Re: 104 East Gilman

Planning & Community & Economic Development

Front Entrance Replacement Plan

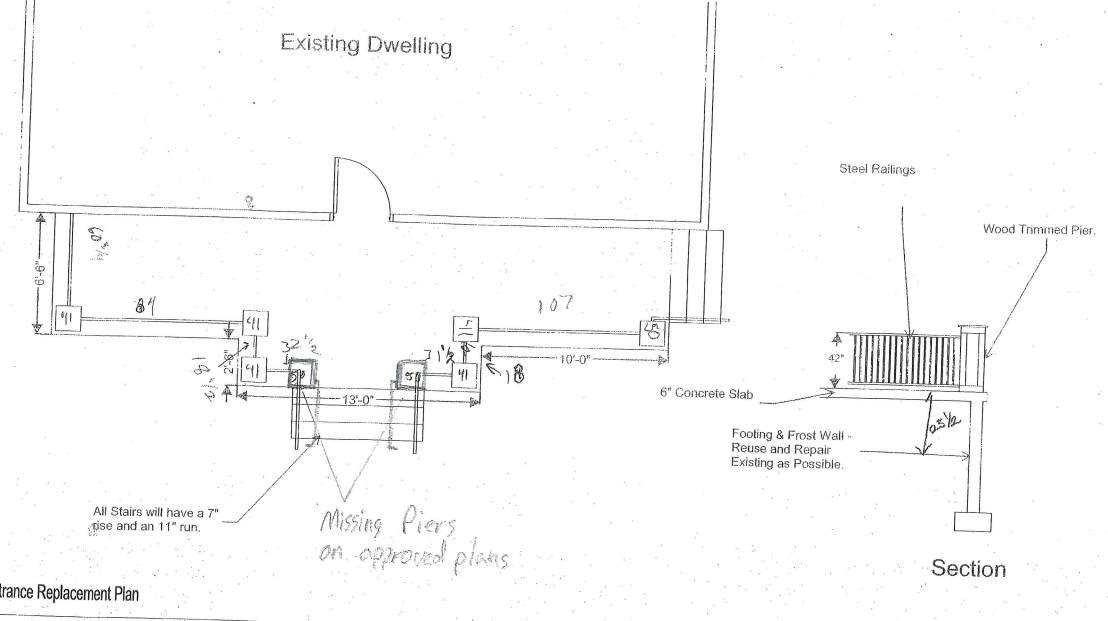
We are asking to keep masonry pier as opposed to wood because brick was the material removed. As to size difference the three larger piers are positioned to accept hand railings to the staircases and are larger to create anchor points. The height of columns will depend on approved railing heights and design. The caps were sized according to close approximation of what was there before.

Railing Detail Center detail salvaged from original railings

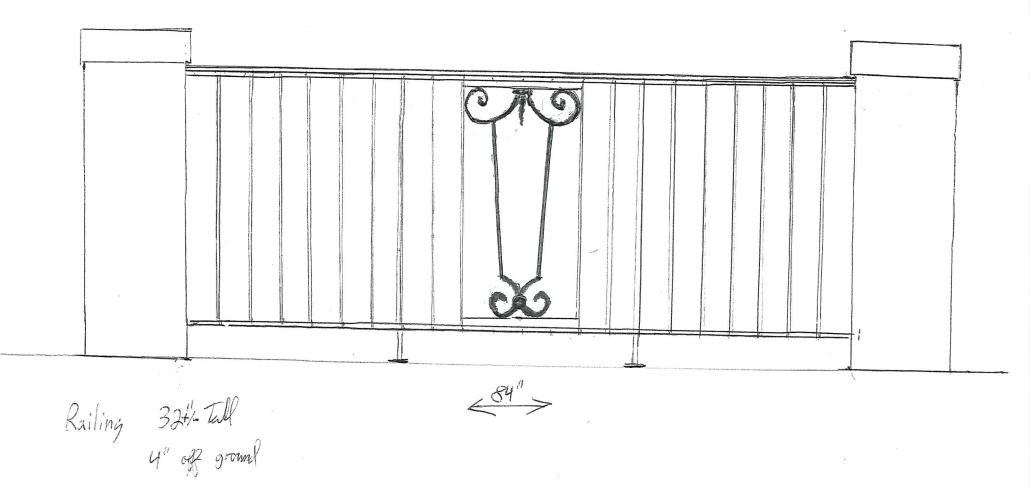
We are submitting plans for a new wrought iron railing. The original railings were in poor condition, but the artistic panel can be salvaged and incorporated into the new design (see drawing). Though the porch height is currently over 24 inches we propose to alter the landscaping to allow for the use of more historically appropriate 36 inch railing height.
